## **NMED Response to LNAPL Friction Point meeting with KAFB on 1/28/21**

Problems identified with the 2 cross sections and location map from the AECOM Technical Memorandum, dated Dec. 17, 2015:

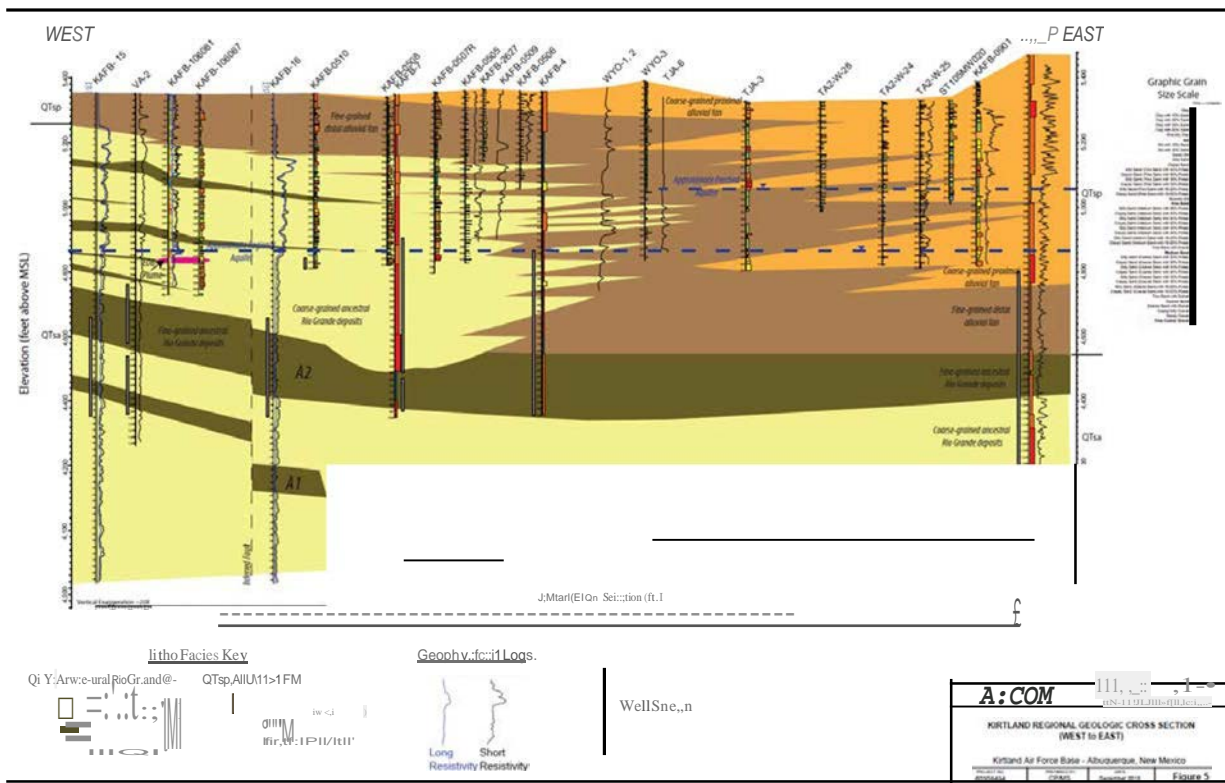
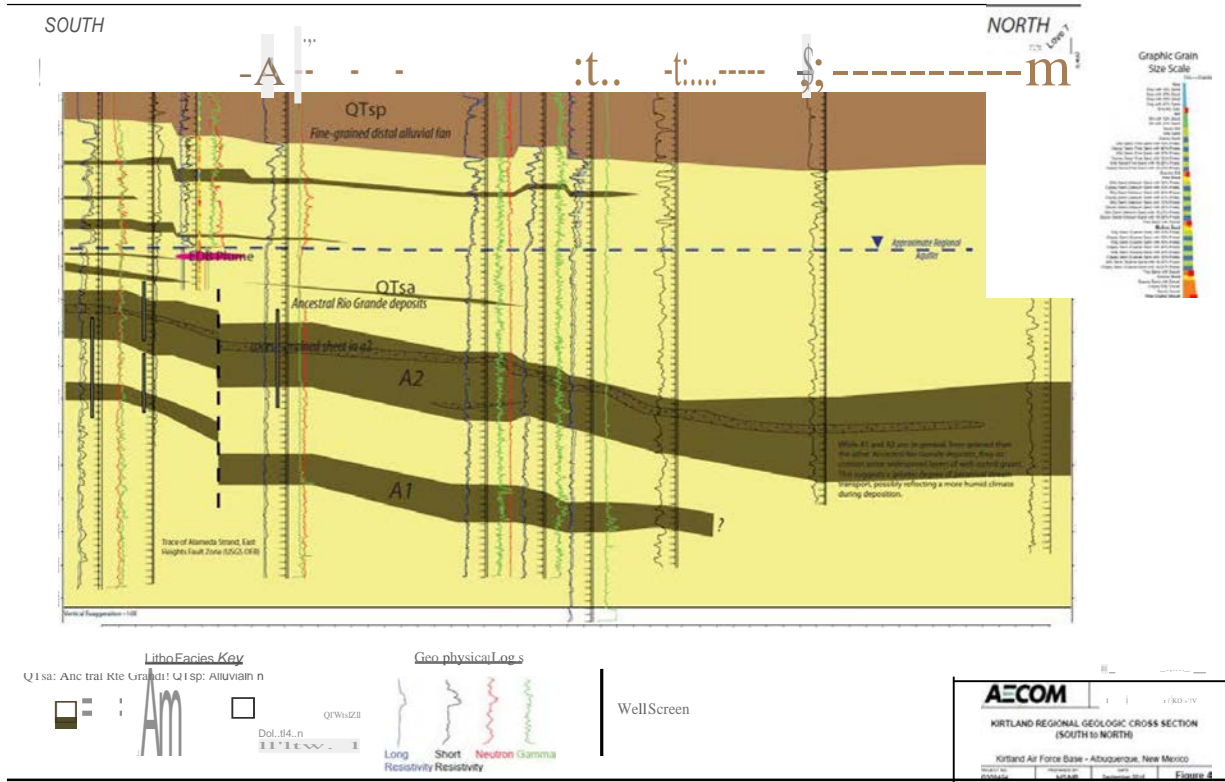
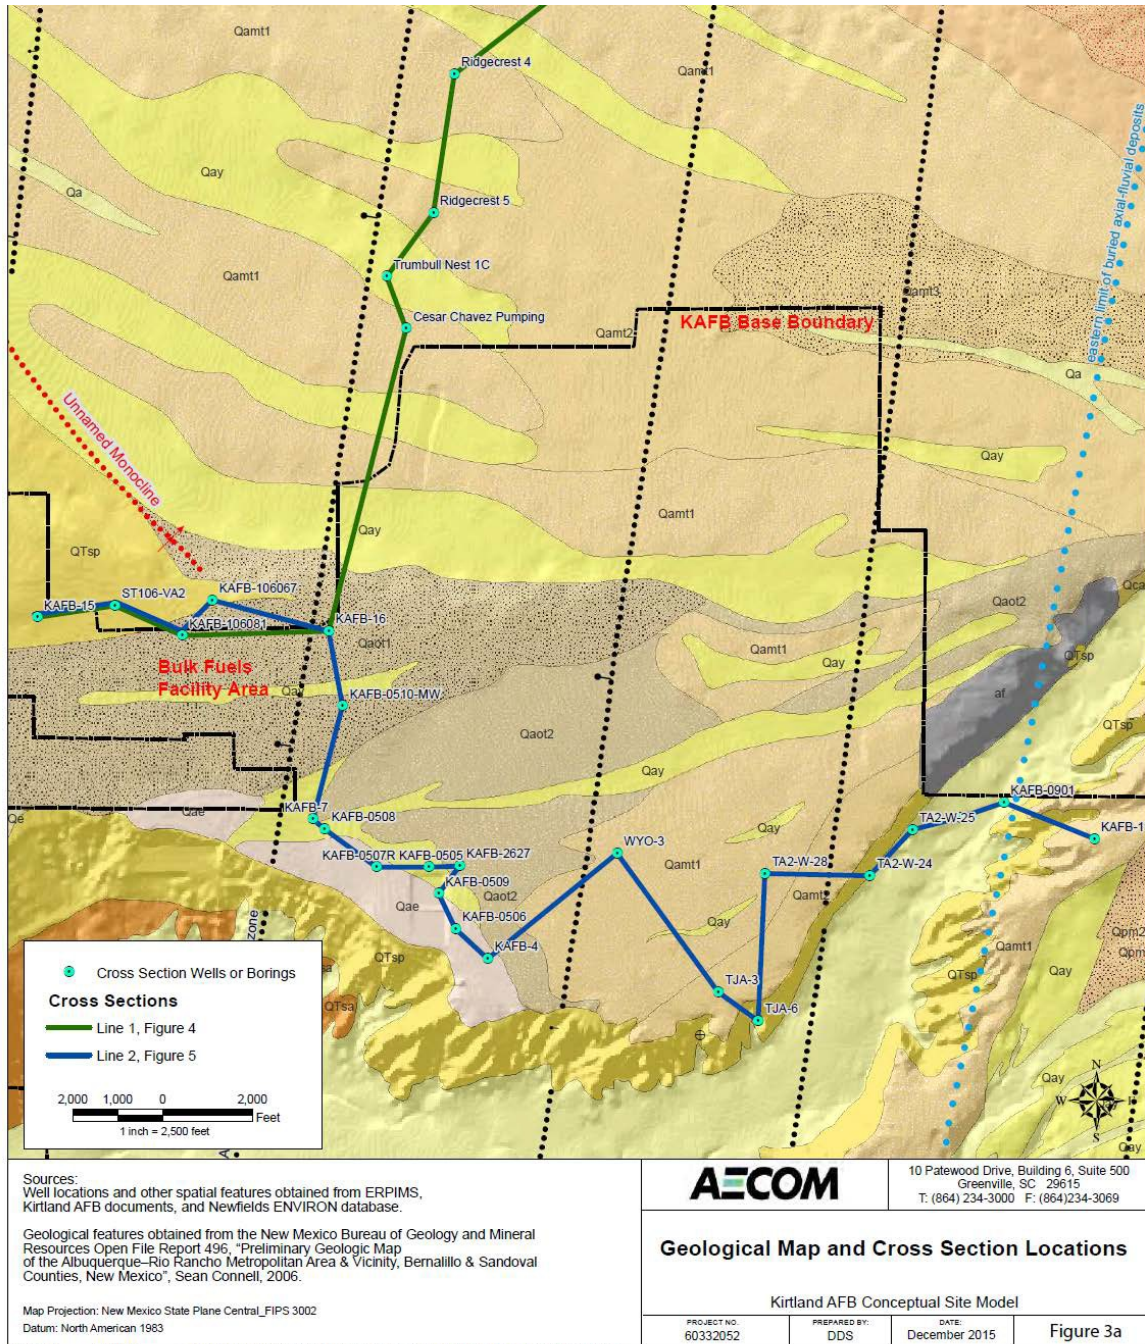
- TJA-3 and TJA-6 are in different locations on the EW cross section and location map compared to each other and the inter-well distances don't match. Look at WYO-3, TJA-6 and TJA-3 on location map and on the east west cross section. On the location map TJA-6 is East of TJA-3 and both are far from WYO-3. Look at the E-W cross section. TJA-6 is west of TJA-3 and close to WYO-3.

- KAFB-7 is west of KAFB-508 on the location map but east of KAFB-508 on the EW cross section.
- The dips of layers are not shown to change, even though the direction of the sections do change (since this is a fence diagram). For example, the 250' clay has the same dip on both sides of KAFB-16 on the EW section even though the direction of KAFB-10667 to KAFB-16 and the direction of KAFB-16 to KAFB-0510 is ~80 degrees apart.

- There are between-well distances that do not match on the cross section figures and location map. Also, both the EW and NS sections have an x-axis of about 28,500 feet yet the total measured distance of each line on the location map seems to differ by about 10%.

- KAFB-10681 has 2 different logs below water table on the 2 sections.
- On a fence diagram breaks in section lines should be shown on the sections.
- While the interfingering between the fine-grained distal alluvial fan and coarse-grained ancestral Rio Grande deposits on the EW section by necessity is schematic, the dips shown are probably in the wrong direction. The dips in the alluvial fan area appear to be toward the east.

- Both water tables (regional and perched) are shown as flat. There is over 100 feet of relief in the regional water table (as can be seen in regional groundwater elevation maps in many Sandia National Laboratories Annual Environmental Restoration Reports) with bearing on the eastern extent of the ancestral Rio Grande deposits. Also, the relief on the perched water table has bearing on the dip of the beds in the area of the perched zone.

- The contaminant plume is shown below the water table instead of at the water table on both sections.
- The horizontal continuity of the clay at 250' depth over 8000 feet and the vertical offsets of about 50 feet in the eastern and southern portions of both cross sections do not seem realistic based upon the other logs in the area not presented. (For instance, the VA EM log and nearby KAFB-106139 do not indicate an equivalent clay (the apparent resistivity values do not appear to be low enough for a clay)). To imply only one continuous clay in the area of the fuel plume does not accurately portray the geology in the area. In fact, it would have been appropriate to draw the cross sections through the FFOR and not to the north along Randolph Road. In the on-base area there are wells with none, one or two fine-grained layers in the 250–300 foot depth zone and the two zones coincide in some areas into one thicker zone.

- The depiction of a single thin continuous clay in the NS cross section in the 250-300 foot depth zone between KAFB-16 and Cesar Chavez SPW without any intervening data is not realistic, especially since a similar section through the axis of the plume to the west would not support that interpretation. In fact, the NS section would have served better if it was drawn through the

axis of the plume where there are a number of data points. For example, in that depth zone KAFB-106093 does not have a fine-grained layer, KAFB-106054 has a single fine-grained layer and KAFB-106058 has 2 fine-grained layers. This is typical of the on-base area around the FFOR.

- The depicted fine-grained deposits don't always agree with the graphic grain size scale on the right of the sections.
- There are wells on the cross sections that are not shown on location map, for example ST105MW020.

- Two wells have slightly different names on the location map and sections, for example, VA-2 or ST106-VA2 and KAFB-0510-MW or KAFB-0510.
- KAFB-16 does not show a coarse section in A2 in the EW section, while it does in the NS section.

- The tops and bottoms of A2 and A1 are shown differently between the EW and NS sections between KAFB-15 and VA2 even though the sections are in exactly the same place.

- The elevation scale on the EW section changes from 100 to 200 feet at the bottom of both eastern and western sides (probably a typo?).
- The fault to the west of KAFB-16 is shown at two different distances from KAFB-16 on the 2 cross sections, even though it should be very close to the same distance.

- On the EW section the fault is shown as extending from the surface downward and is called "inferred fault". On the NS section it is shown as not reaching the surface and is given a USGS OFR reference (trace of Alameda strand). There is no such reference in the list of references in the text accompanying the figures, but the reference should be the NMBG&MR map used as the base for the location map. The question of how high in the section the fault goes also has bearings on A2 and the sense of throw (see first item in "Disagreements" below).

- The fault near KAFB-16 is shown on the cross sections with the opposite throw as on the location map (based on NMBG&MR). The NMBG&MR down to the west movement is based on deeper stratigraphic and structural considerations. It doesn't seem probable that this is both a typical down to the west fault and an antithetic fault. It would be difficult to show down to the east movement. It is not clear that the down to the east offsets in A1 and A2 shown on the 2 sections are necessary (other interpretations based on the elogs are also possible.)

- The location map (based on NMBG&MR) shows more faults than are shown on the cross sections.
- The eastward extent of the ancestral Rio Grande deposits is shown on the sections as extending further east than shown on the location map (NMBG&MR) and in Sandia National Laboratories (SNL) reports (for example, Van Hart, 2003).
- Connell et al. 1998 (discussed in the accompanying text to the figures but is not in the list of reference) implies there may not be an A2 layer in Love7.
- Cross section C-C' in the NMBG&MR OFR that the base map is taken from shows Love 7 bottoming in a different geologic unit than shown on the NS section.
- The stratigraphic interpretation of the area around WYO-1, WYO-2 and TJA-6 differs from SNL's interpretation (for example Van Hart, 2003).
